Point Beach Nuclear Plant
Operated by Nuclear Management Company, LLC

Point Beach Nuclear Plant, Units 1 and 2
Dockets 50-266 and 50-301
License Nos. DPR-24 and DPR-27

License Amendment Request Number 247: Spent Fuel Pool Storage Criticality Control

**ENCLOSURE 1
DESCRIPTION AND ANALYSIS OF CHANGE**

Figure 3.7.12-1 (page 1 of 1)
Fuel Assembly IFBA Requirements

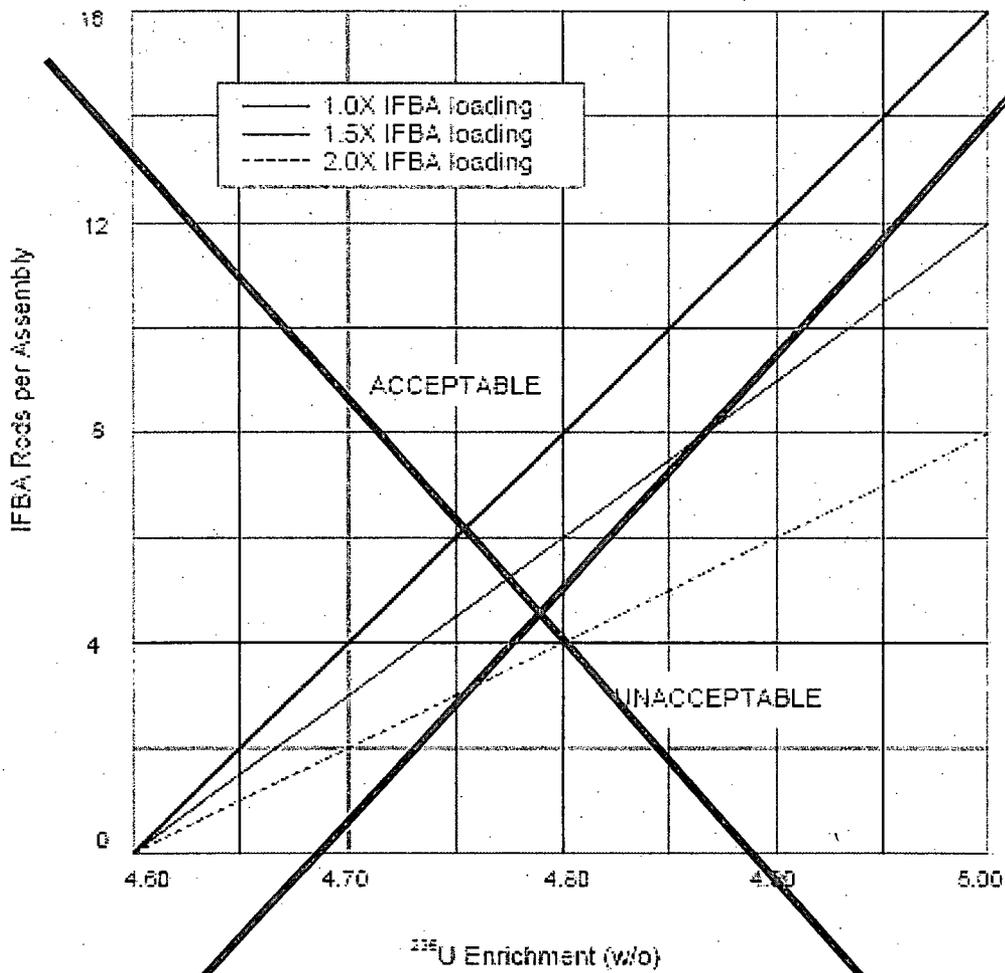
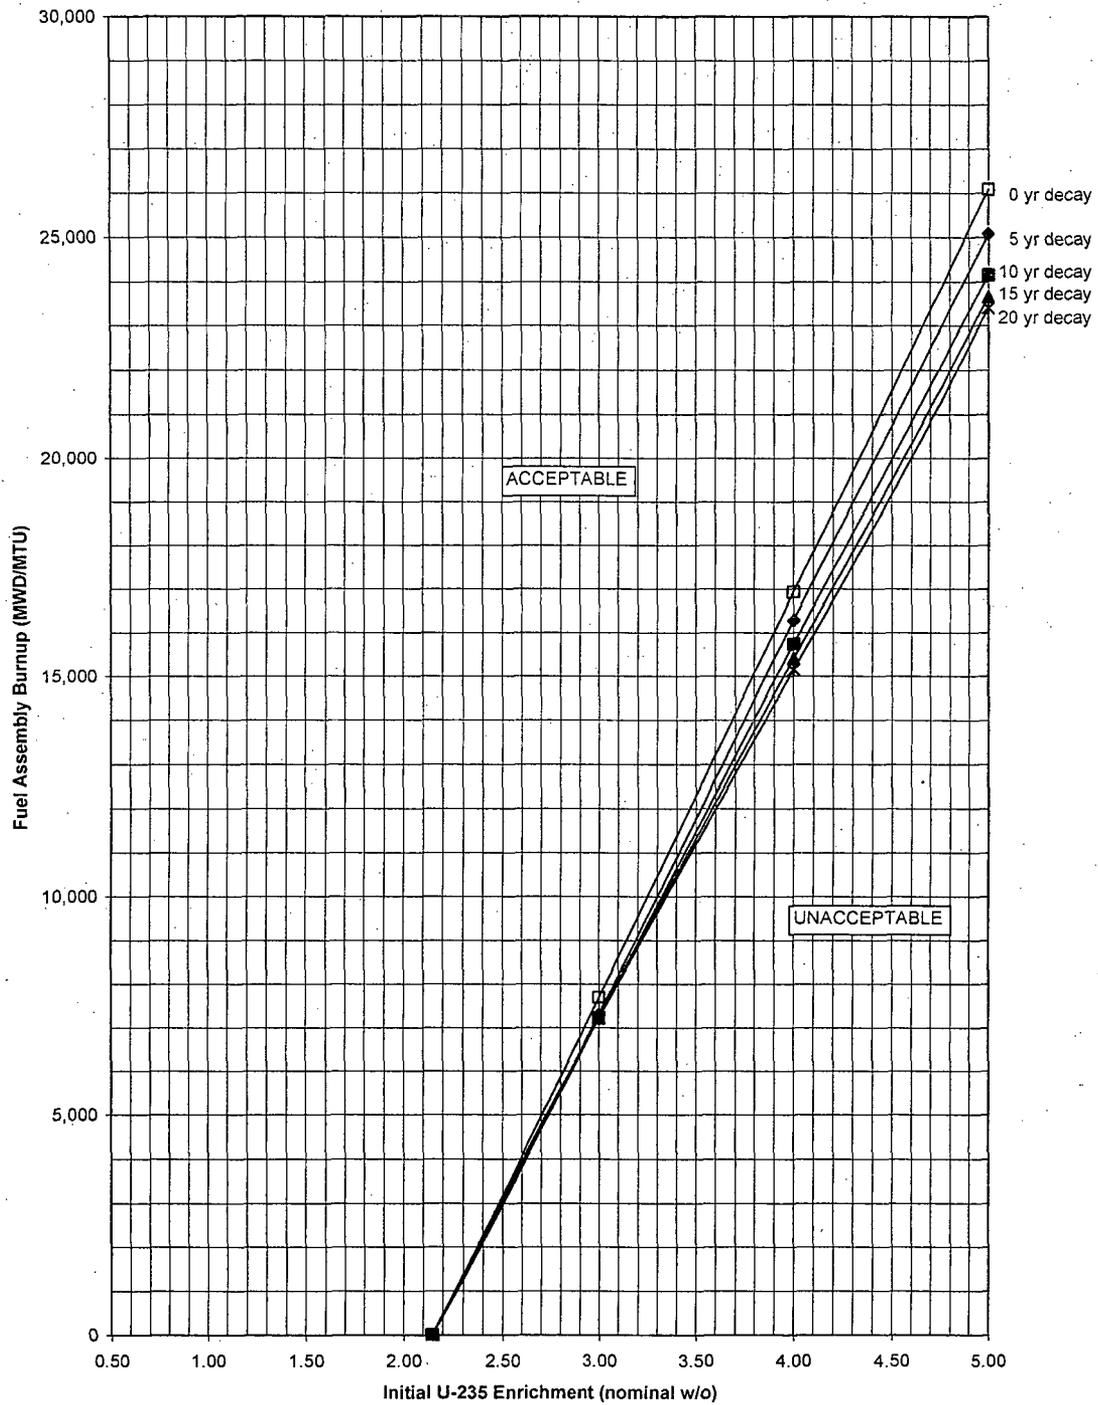
Existing Figure 3.7.12-1 and the present LCO 3.7.12 wording (restated below),

- LCO 3.7.12 (Old) Fuel assembly storage in the spent fuel pool shall be as follows:*
- a. Fuel assembly initial enrichment $\leq 4.6\%$ w/o U-235; or*
 - b. Fuel assembly contains Integral Fuel Burnable Absorber (IFBA) rods within the "acceptable" range of Figure 3.7.12-1.*

- a. Fuel assembly initial enrichment $\leq 4.6\%$ w/o U-235; or
- b. Fuel assembly contains Integral Fuel Burnable Absorber (IFBA) rods within the "acceptable" range of Figure 3.7.12-1.

will be replaced by a new Figure 3.7.12-1 and revised LCO 3.7.12 wording as stated below.

- LCO 3.7.12 (New) The combination of initial enrichment, burnup and decay time of each fuel assembly stored in the spent fuel pool shall be within the Acceptable range of Figure 3.7.12-1 or in accordance with Specification 4.3.1.1.*

Figure 3.7.12-1
Fuel Assembly Burnup Requirement of "All-Cell" Storage Configuration

Figure 4.3.1-1
1-Out-of-4 for 5 w/o with no IFBA Storage Configuration

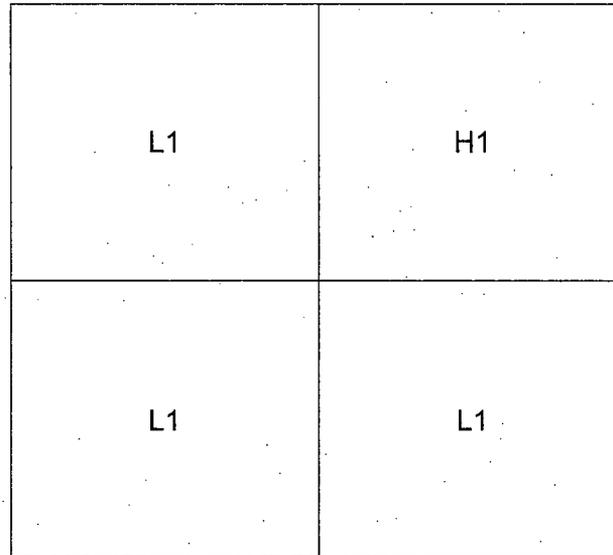
- Add the following figures to Specification 4.3.1:

<u>Figure</u>	<u>Description</u>
4.3.1-1	1-Out-of-4 for 5 w/o with no IFBA Storage Configuration.
4.3.1-2	1-Out-of-4 for 4 w/o with IFBA Storage Configuration.
4.3.1-3	1-Out-of-4 for 5 w/o with no IFBA / "All Cell" Interface.
4.3.1-4	1-Out-of-4 for 4 w/o with IFBA / "All Cell" Interface.
4.3.1-5	1-Out-of-4 for 4 w/o with IFBA / 1-Out-of-4 for 5 w/o with no IFBA.
4.3.1-6	Spent Fuel Assembly Burnup Requirements for 1-Out-of-4 for 5.0 w/o with no IFBA.
4.3.1-7	Spent Fuel Assembly Burnup Requirements for 1-Out-of-4 for 4.0 w/o with IFBA.
4.3.1-8	Fresh Fuel IFBA Requirements.

- f. *New or spent fuel assemblies with a combination of discharge burnup, initial enrichment and decay time in the "Unacceptable" range of Figure 3.7.12-1 will be stored in compliance with Figures 4.3.1-1 through 4.3.1-8.*
